**BYERWEN
COAL**

Byerwen Coal Project Southern Infrastructure Relocation – Change Request

Byerwen Coal Project – Assessment of Potential Impacts on Values associated with the Relocation of Southern Infrastructure

Figure 1: Existing and Relocated Southern Infrastructure (current ML boundary)

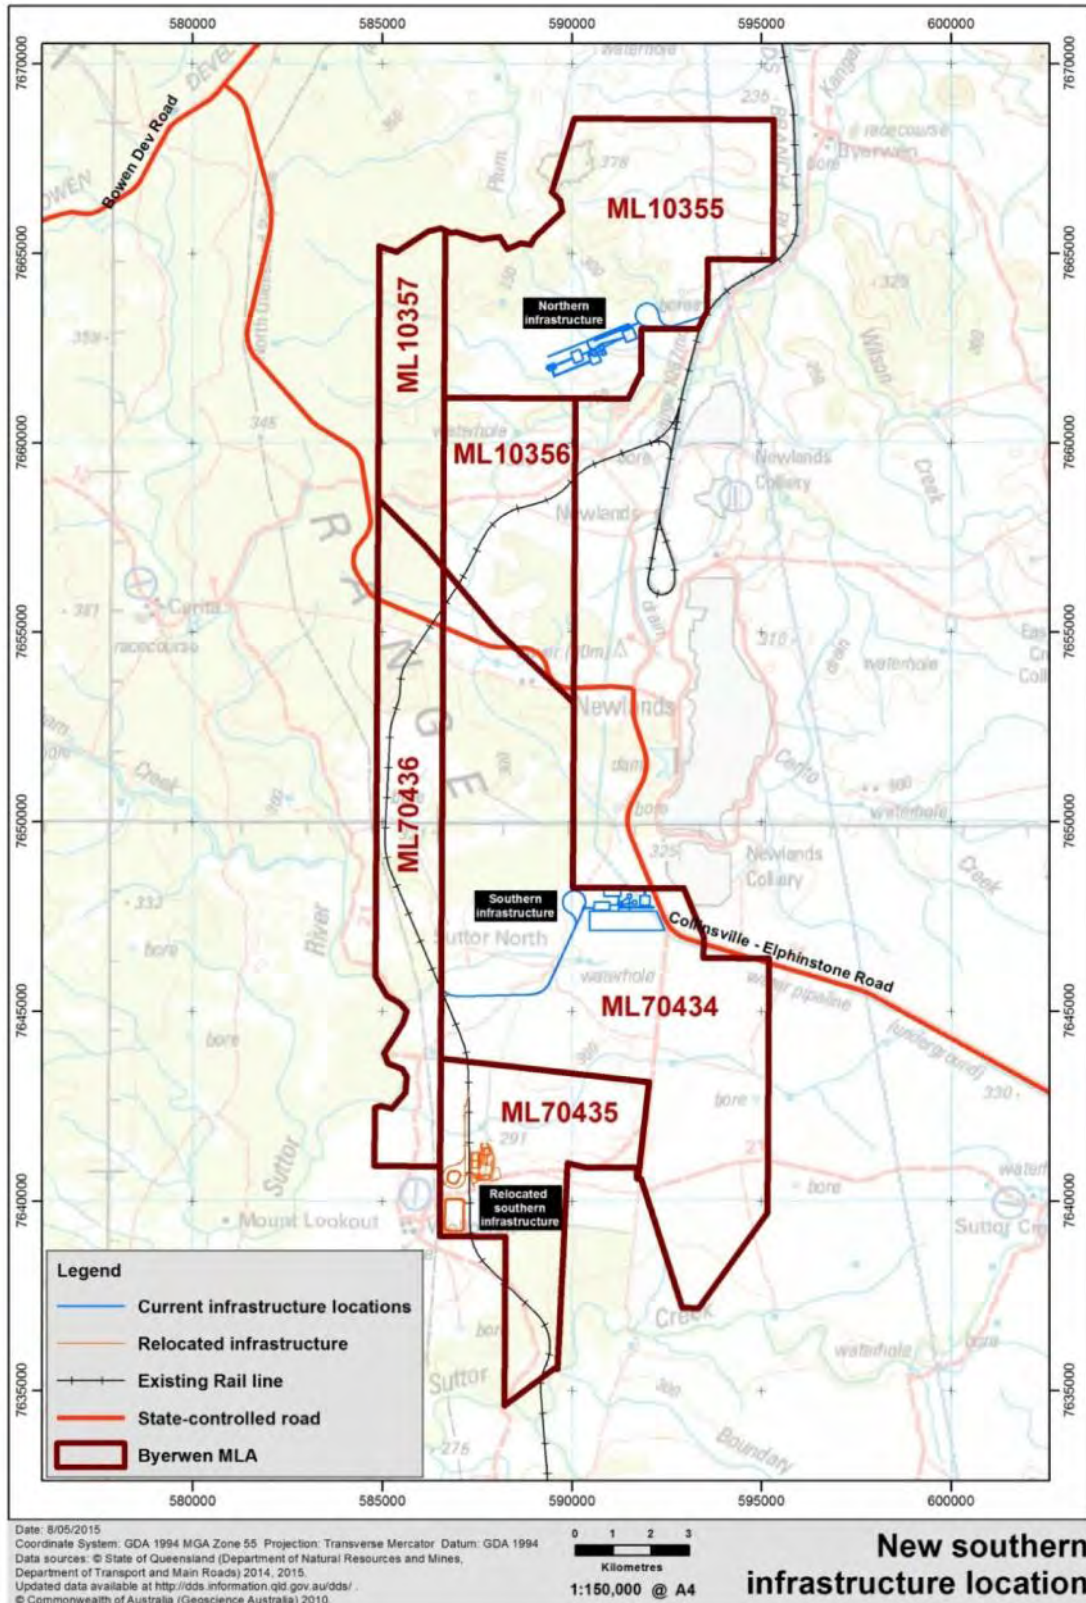
Presented in **Figure 1**, is the existing location and the proposed new location of the southern infrastructure, in the south eastern corner of the Project. The new location was identified to enable faster construction schedules, significant cost reductions across construction and operation, more specifically the new location was identified to enable:

- Net reduction of ~3.1 km of rail requirements across the Project area and the removal of rail from across the Project area, with the relocated rail loop being adjacent to the GAP rail line. This represents a notable reduction in actual impacts, as well as reduced coal sterilisation compared to the original alignment.

- Net reduction of ~6km of water pipeline construction requirements, with the southern infrastructure being relocated closer to SunWater's Burdekin to Moranbah pipeline (a source of process makeup water).

Figure 1: Relocated southern infrastructure (current ML boundary)

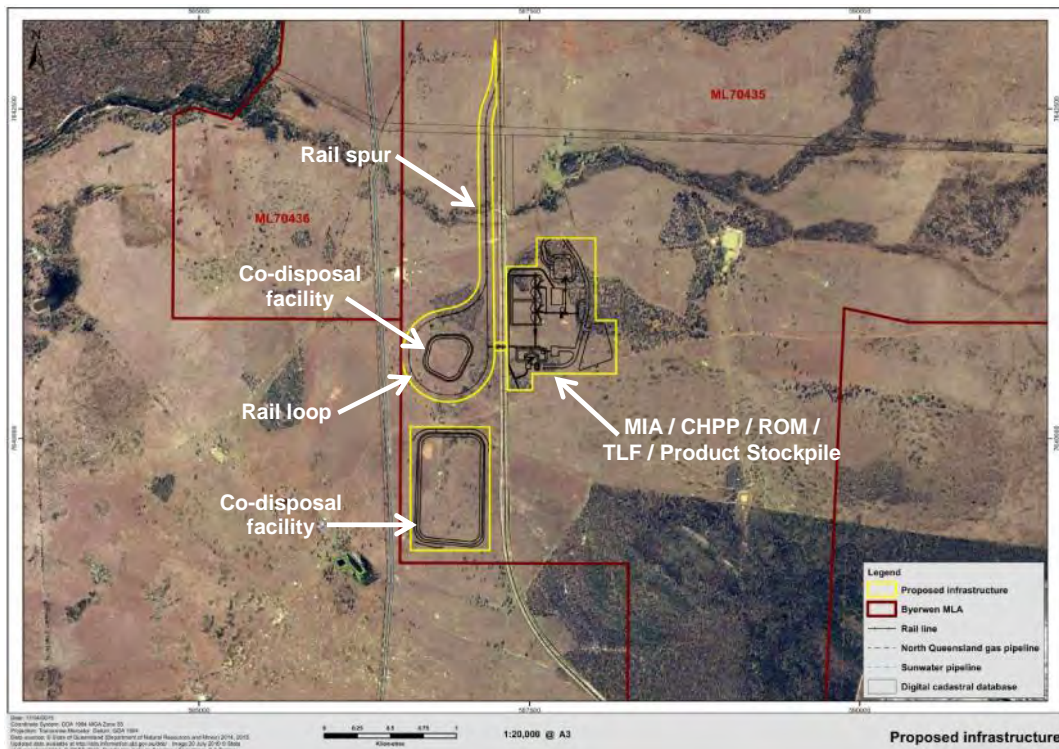
Shown in **Figure 1** is the relocated southern infrastructure layout.

Figure 2: Approved disturbance area around relocated southern infrastructure (current ML boundary)

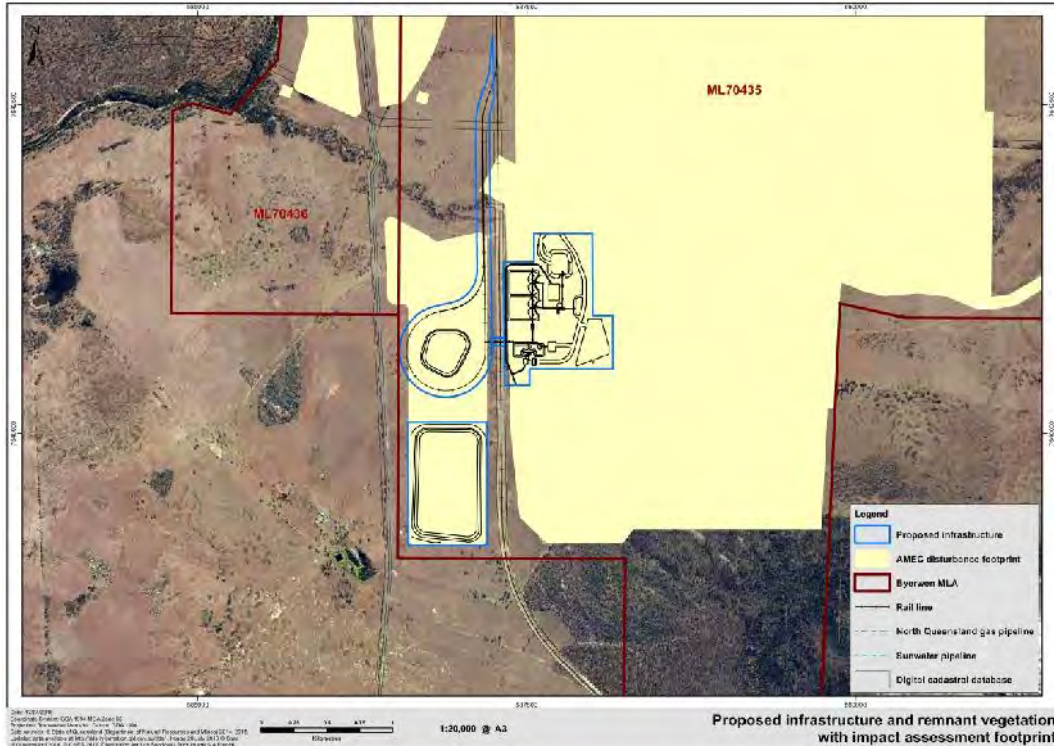
Shown in **Figure 2**, is the approved clearance area for the southern section of the Project and the new location of the southern infrastructure. As is shown the new location has been selected to ensure it is primarily within approved disturbance areas, with the exception of a small section of rail (the rail spur) which is not within the current identified disturbance area. The rail spur section is assessed in **Section 2 - Land, Rehabilitation and Ecology Offsets** (Schedule H), of this document.

This means that the new location for the southern infrastructure has previously been approved for clearance (except for the rail spur).

Figure 3: Relocated Southern Infrastructure over EIS layout (current ML boundary)

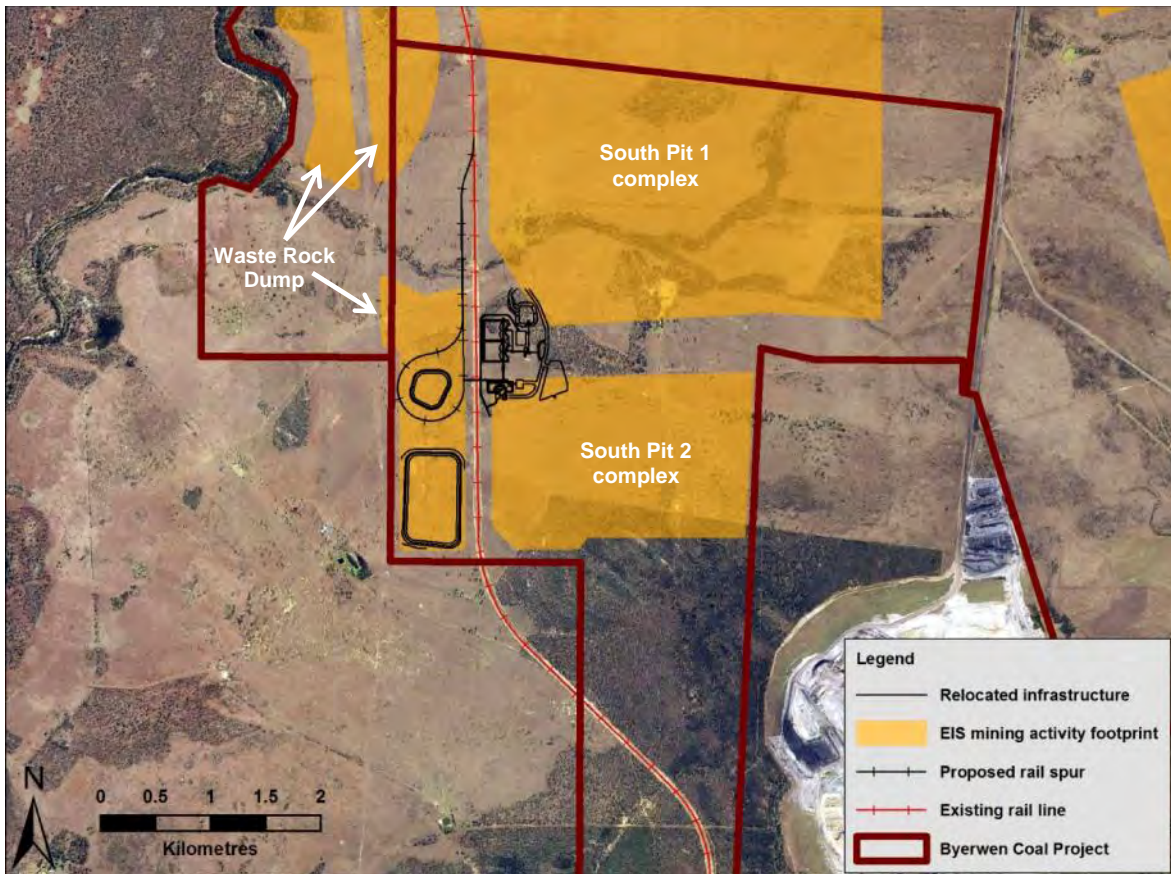
Shown in **Figure 3** is the proposed new location of the southern infrastructure overlaid over the EIS layout of the area. As can be seen the rail loop and rejects facilities are located on what was previously designated as waste rock dump. The CHPP, MIA and ROM are located partially on South Pit 1 dump, partially on South Pit 2 dump and partially on buffered disturbance area.

From an operational context the loss of waste rock dump space was specifically considered. A process of continual review and improvement in design and mine plan has been ongoing since 2012, prior to the financial commitment associated with commencing construction. That process has identified a more suitable location for the southern infrastructure with the proportionate loss of waste rock dump area. Accordingly a review of the materials balance in the initial stages of mining was undertaken to factor in the loss of this area as dump space. The materials balance has been updated since 2012 with more site specific data and more detailed mining layout/designs, such that the area of waste rock dump is no longer required and the materials balance retains the same ratios, without any additional dumps or changes to existing dumps.

Figure 4: Updated mining sequence and haul roads (current ML boundary)

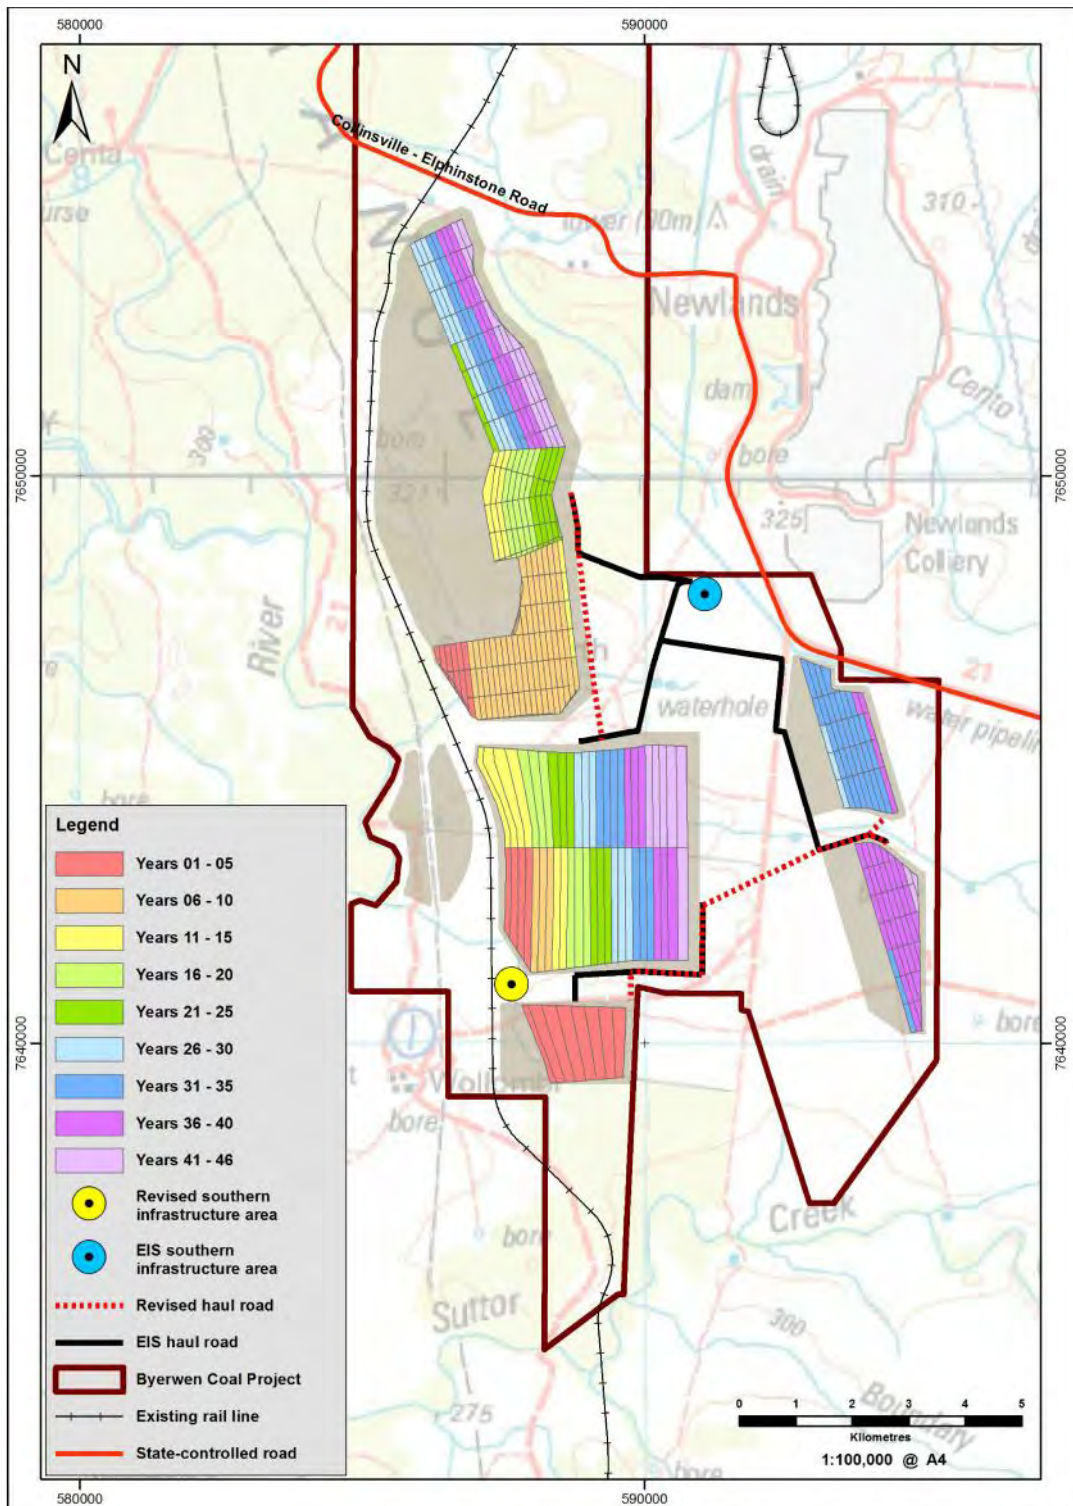
The relocation of the southern infrastructure has been identified as a more cost efficient model, especially for the early years of mining, when the Project commences. The mining sequence presented in the EIS has been updated as per **Figure 4**.

As is shown the commencement of mining will be in South Pit 2, the south western corner of South Pit 1, and a small section of West Pit 1. This updated schedule is linked to the updated southern infrastructure location and is a result of the process of continual review and improvement. The previous and updated haul road configuration is shown.

The EIS layout haul road configuration for the entire Project was 23.7km. The revised haul road configuration for the entire Project with the relocated southern infrastructure is 14.5km. A 9.2km reduction in haulage road requirements associated with the relocated southern infrastructure, over a continuous driving loop 24hr/day, 7day/week for ~50 years is a substantial reduction in operational haulage hours, haulage circuit distances and costs.

Figure 5: 1,000 year ARI event flood extent with relocated southern infrastructure (current ML boundary)

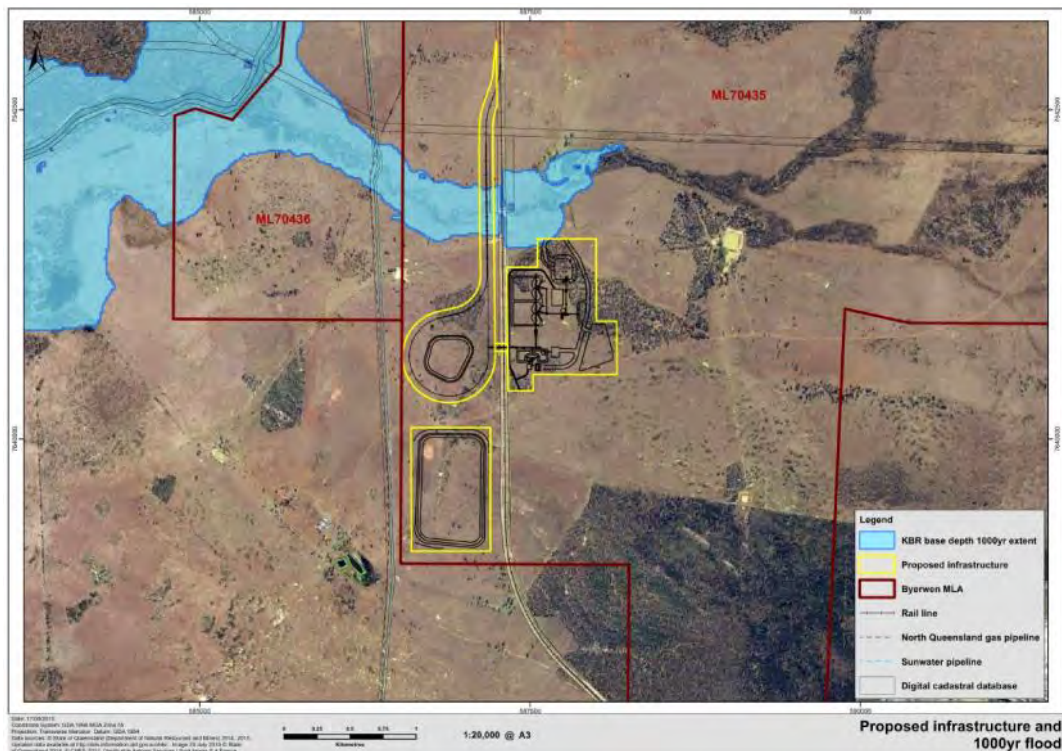
The results indicate that the new location is above the existing 1,000 year ARI event and as such does not need any commensurate flood protection. It is noted that the relocated rail spur linking the rail loop to the GAP rail line crosses the unnamed tributary and as such the bridge will be designed accordingly.

The new location of the southern infrastructure is partially situated on the final section (final ~1km) of a diversion (designated Diversion 2 in the OCG Report and EIS documentation), where the diversion feeds back into the natural watercourse alignment.

Accordingly that final ~1km section of Diversion 2 will be designed to flow as presented as summarised below:

- from immediately upstream of the southern infrastructure (the eastern side);
- around the northern edge of the southern infrastructure area; and
- back into the natural watercourse alignment.

Figure 7: REs/Offset area (southern section) with relocated southern infrastructure (current ML boundary)

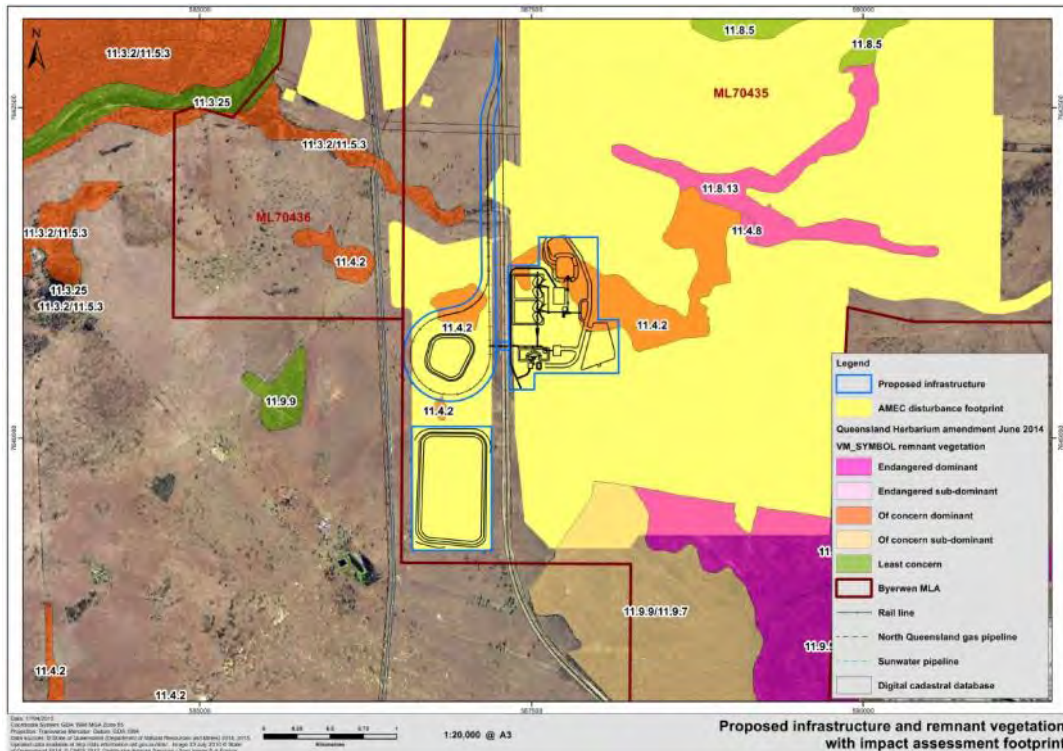
Presented in **Figure 7** are the Regional Ecosystems (RE) in the southern section of the Project (Queensland Herbarium, June 2014), with the current disturbance footprint and the relocated southern infrastructure. Those areas of RE impacted by the relocated southern infrastructure have already been considered in impact assessments, subsequently approved for disturbance and are addressed accordingly in the Biodiversity Offset Strategy. As is shown there is no additional impact to RE associated with the relocation of the southern infrastructure and as such no change to the ecology impact mitigations already in development.

As for the Queensland ecology, **Figure 7** shows the southern infrastructure within approved disturbance areas, except for the rail spur which does not intersect vegetation. Accordingly as clearing of the footprint has already been approved, there is no additional impact to MNES ecology from relocating the southern infrastructure.
